BusConnects Core Bus Corridors

Ringsend to City Centre Core
Bus Corridor

Stage 1 Road Safety Audit

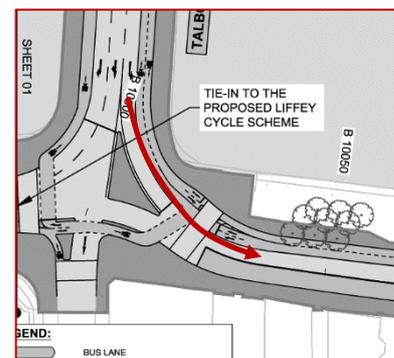
Location: Drawing No BCIDD-ROT-GEO_GA-0016_XX_00-DR-CR-0001 (L03 S3)

Summary: Potential for large vehicles to encroach onto cycle track.

It is unclear if the left-turn lane from Talbot Memorial Bridge onto City Quay can accommodate the swept path of a large vehicle without encroachment into the adjacent two-way cycle track.

Vehicles encroaching upon the two-way cycle track could increase the likelihood of a vehicle/cyclist collision.

It is recommended that separation be provided between the carriageway and the cycle track, and that a swept-path analysis is undertaken to ensure that all vehicles can complete this turn within the proposed road layout.

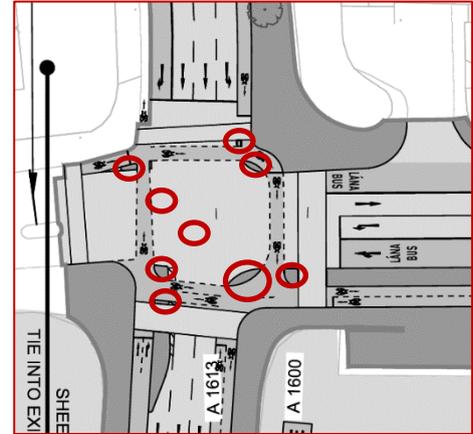
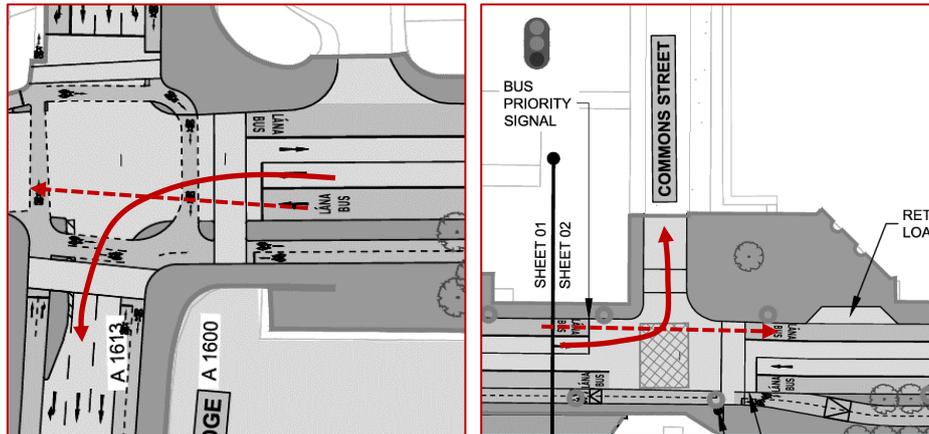
Summary: Small islands proposed at signalised junctions may be impractical to sign, and lead to these islands being struck.

Small islands have been indicated within signalised junctions to separate vehicle, cyclist, and pedestrian movements. The relatively small size of the islands, and their number within a junction, may be impractical to sign, and lead to these signs being struck by vehicles and cyclists, leading to material damage and loss of control collisions.

Ensure physical islands can accommodate traffic signs and provide at least 450mm between the carriageway edge and the sign.

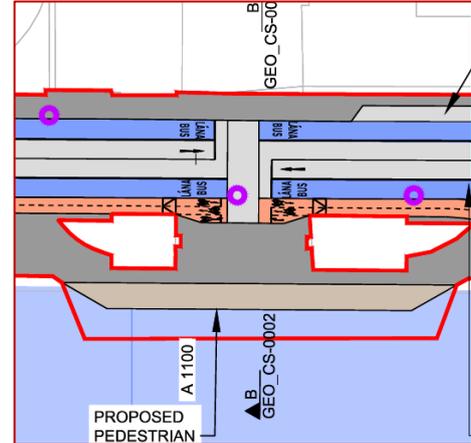
Summary: Risk of general traffic turning left across straight-ahead bus movements, resulting in side-on collisions.

Details of the proposed signal phasing have not been provided at this stage in the design process. Where “Bus Priority Signals” are proposed, it is unclear if the general traffic lane will be held while buses proceed, and conversely that buses will be held while general traffic proceeds.

Should all traffic proceed on the same signal phase, there is an increased risk of side-on collisions between left turning traffic and straight-ahead buses/cyclists, resulting in side-on and vehicle/cyclist collisions.

Ensure that the general traffic lane operates on a separate signal phase to the bus and cycle lane(s).

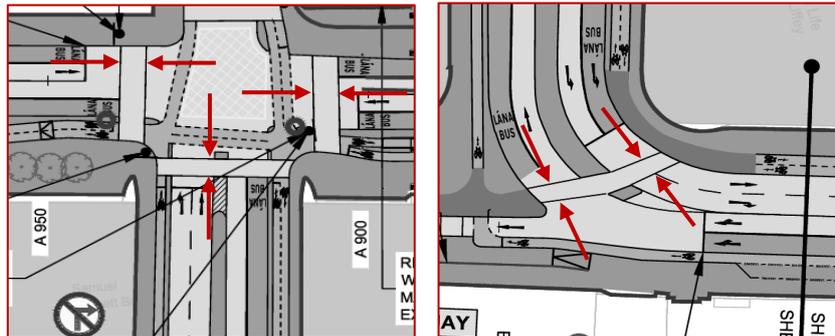
Summary: Drivers may have limited visibility to some signals at the signalised crossing on North Wall Quay, leading to an increased risk of overshoot and vehicle/pedestrian collisions.

It is unclear what type of signal supports (e.g. standard height, high mast, cantilever, etc) are proposed at the signalised crossing located on the North Wall Quay. There is a risk that the traffic signal location on the southern footway, which is offset from the carriageway, may be outside a driver's eyeline on approach to the signalised crossing, and possibly blocked by the nearby buildings either side of the crossing. This could increase the likelihood of overshoot and vehicle/pedestrian collisions.

In addition, a bus within the bus lane at the crossing stop line may obscure visibility towards the signals for an approaching driver in the general traffic lane, which may also result in overshoot and vehicle/pedestrian collisions.

Ensure that approaching drivers have adequate visibility to the upcoming signals. This may require the provision of high-mast or cantilever-type signal supports.

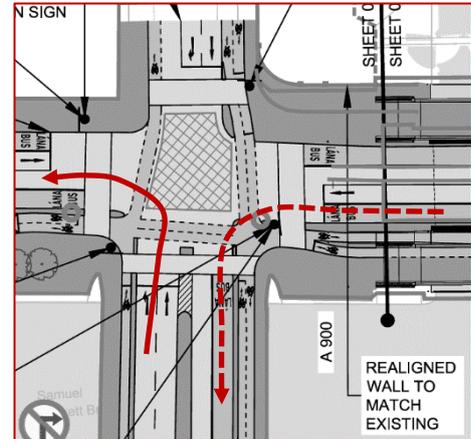
Summary: Proposed crossing widths at signalised pedestrian crossings may be insufficient for the anticipated high pedestrian volumes.

The pedestrian crossing widths indicated appear to be relatively narrow given the likely volumes of pedestrians during peak times, particularly near the Convention Centre (e.g. on the northern & southern side of the Samuel Beckett Bridge). This may be of increased concern on the southern side of the Samuel Beckett Bridge, which is a Toucan crossing.

Provide signalised crossings at least 4m wide (Ref: DMURS section 4.3.2, page 92).

3.1	Yes	Yes		
3.2	Yes	Yes		
3.3	Yes	Yes		
3.4	Yes	Yes		
3.5	Yes	Yes		
3.6	Yes	No	Space constraints prevent a blanket provision of 4m wide crossings everywhere within the scheme. Where space allows we have widened all crossings to up to 4m. At Beckett Bridge south however, the design is especially constrained by levels and opening bridge paraphernalia and the layout as constructed is the most that can be achieved at this location. The existing crossing layout is being retained with enhancements to the footpaths and cycle facilities on each side where practicable.	Yes

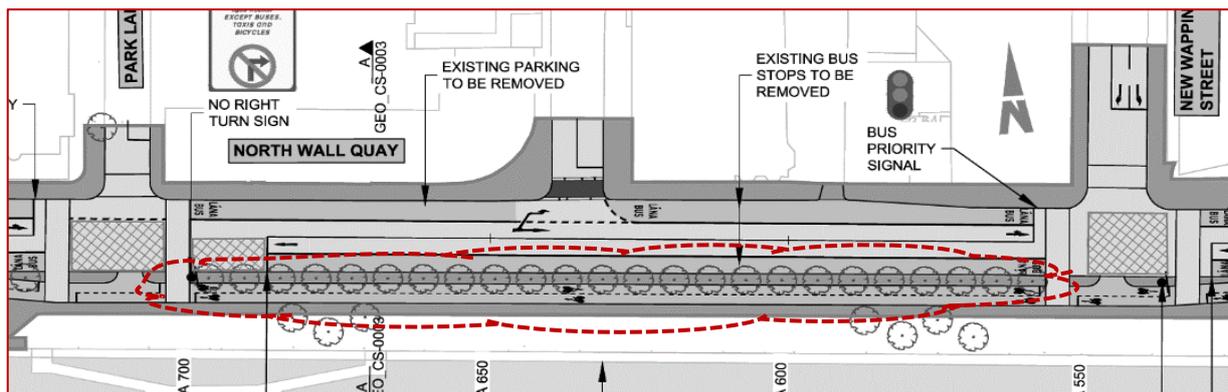
Summary: Large vehicles may fail to navigate left-turns without mounting the kerbs, leading to vehicle/pedestrian, vehicle/cyclist, and material damage collisions.

It is unclear if buses are intended to turn left from Spencer Dock onto the Samuel Beckett Bridge. If this manoeuvre is anticipated in the future, the proposed road layout may not accommodate the swept path of a bus undertaking this manoeuvre. Similarly, it is unclear if a large vehicle or a bus can undertake a left turn from Samuel Beckett Bridge onto the North Wall Quay without encroaching into the opposing traffic lane, or mounting the kerb on the inside of the turn.

Modifications to the existing junction radii may increase the risk of kerb strikes, vehicle/pedestrian, vehicle/cyclist, and material damage collisions.

A swept-path analysis should be undertaken at each junction to confirm that large vehicle movements can be accommodated safely within the proposed road layout.

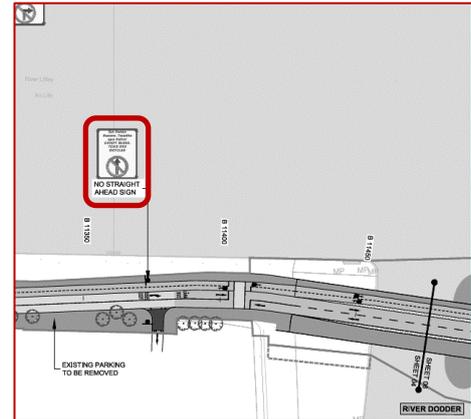
Summary: Trees and their canopies may increase the risk of bus strikes and reduced visibility, leading to material damage and side-on collisions, or present a hazard to cyclists on the adjacent cycle track.

Tree planting is indicated on North Wall Quay, between CH A550 and CH A700. The tree canopies may, as they mature, overhang the bus corridor, increasing the risk of bus strikes and material damage collisions.

Low hanging tree canopies may present a hazard to cyclists on the two-way cycle track, leading to personal injury collisions.

Care will be required during the subsequent Design Development phases to ensure that the tree species chosen have canopies, when mature, that will not present a hazard to vehicles travelling in the adjacent bus lane, or to cyclists on the two-way cycle track.

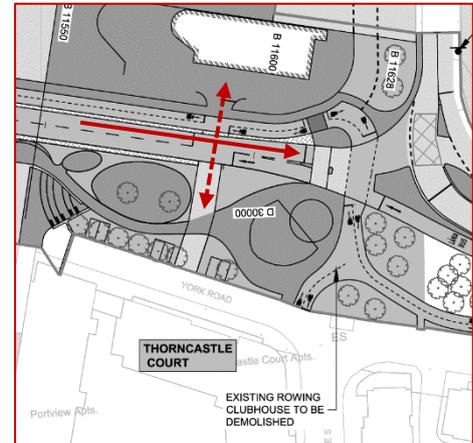
Summary: Lack of pedestrian facilities between Pembroke Cottages, the new Dodder Sustainable Transport Bridge, and the Tom Clarke Bridge may lead to vehicle/pedestrian and pedestrian/cyclist collisions.

No pedestrian facilities have been indicated between the Zebra crossings at Pembroke Cottages, the new Dodder Sustainable Transport Bridge, and the Tom Clarke Bridge. It is therefore unclear how pedestrians in the Ringsend and Irishtown residential catchment areas will access the footways on the new Dodder Sustainable Transport Bridge or the existing Tom Clarke Bridge.

The absence of appropriate pedestrian facilities may lead to pedestrians travelling within the two-way cycle track, or within the York Road carriageway, where there is an increased risk of pedestrian/cyclist and vehicle/pedestrian collisions.

A pedestrian footpath, which ties in with a controlled crossing of York Road, should be provided between Pembroke Cottages and the new Dodder Sustainable Transport Bridge/ Tom Clarke Bridge, ensuring that pedestrian/cyclist conflicts are minimised.

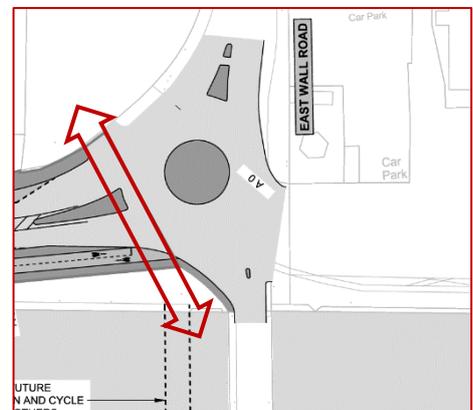
Summary: The close proximity of signals may lead to driver confusion, resulting in overshoot, rear-end-shunt and side-on collisions.

It is unclear if it is proposed to provide signals on the new Dodder Sustainable Transport Bridge for access to the rowing club. The road layout indicated implies that signals will be provided to facilitate access across the sustainable transport bridge carriageway and the two-way cycle track.

The proximity of the signals to the downstream junction signals could result in eastbound drivers misinterpreting the first set of signals as applying to the downstream junction, resulting in overshoot, rear-end-shunt and side-on collisions.

Provide measures at the rowing club signals to reduce the risk of eastbound drivers misinterpreting the first set of signals as applying to the downstream junction (e.g. both sets of signals operating in-phase).

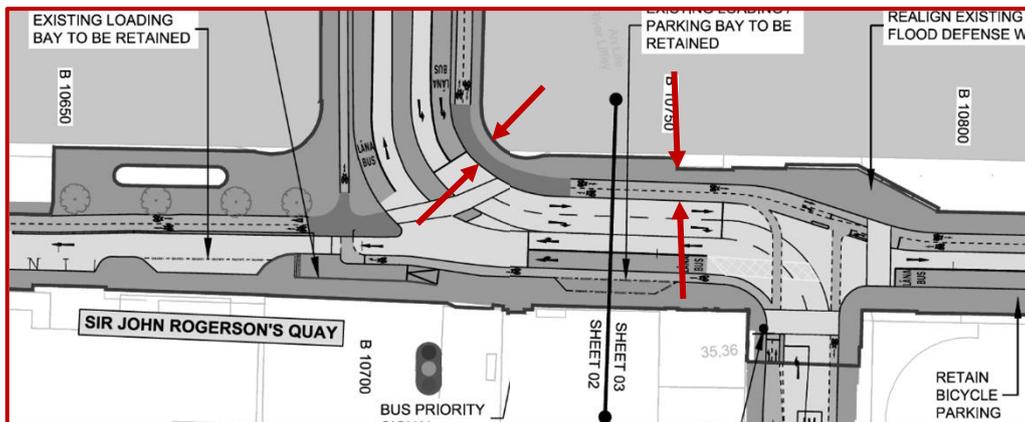
Summary: Removal of existing vehicle restriction on Pigeon House Road may lead to the re-introduction of high traffic volumes on a narrow residential street, increasing the risk of vehicle/cycle and material damage collisions.

Dublin City Council is currently (May 2021) trialling a vehicle restriction on Pigeon House Road. The restriction prevents motorists on Pigeon House Road from accessing the Sean Moore Road Roundabout, and vice versa. It is unclear if the Ringsend to City Centre Core Bus Corridor Scheme proposes to remove the restriction on through-traffic on the Pigeon House Road.

Removing any existing restrictions could result in a significant diversion of traffic through the relatively narrow local streets to the west of this location, along which is intended to route cyclists to/from the new facilities on Sir John Rogerson's Quay. This may lead to an increased risk of vehicle/cycle and material damage collisions.

The Design team should consult with Dublin City Council to understand the trial's conclusions before determining whether the restriction should be retained or removed.

Observation 4.2

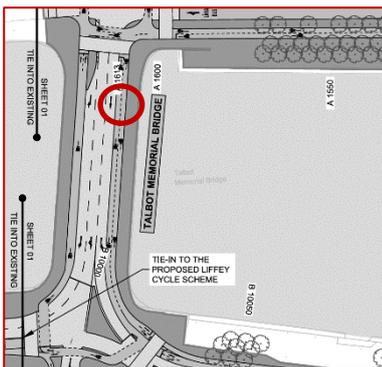
4.2 The Talbot Bridge nearside lane shows a straight-ahead arrow in a lane that can only turn left downstream. The straight-ahead arrow should be replaced by a left turn arrow.

Observation 4.3

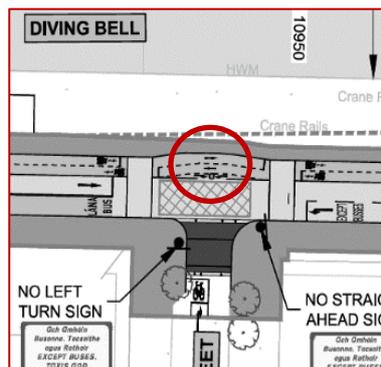
4.3 The proposed arrangement for cyclists to access side roads at a number of locations on the south quays (e.g. at Forbes Street) from the two-way cycle track appears unnecessarily complicated. Cyclists could use the adjacent toucan crossings to access the side roads at these locations.

Observation 4.4

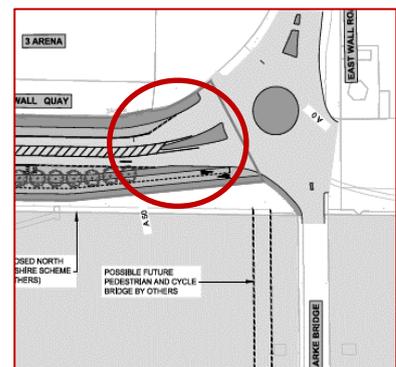
4.4 The eastbound approach to the existing roundabout on the northern side of the Tom Clarke Bridge is poorly defined. The existing arrangement has two lanes entering the roundabout, one for left-turning traffic and one for right-turning traffic. Vehicles in the general traffic lane on North Wall Quay will have to move left in order to turn left at the roundabout. The absence of appropriate guidance may result in late lane-change manoeuvres and possible side-swipe collisions. Provide guidance markings to support good lane discipline and clear direction for approaching drivers.
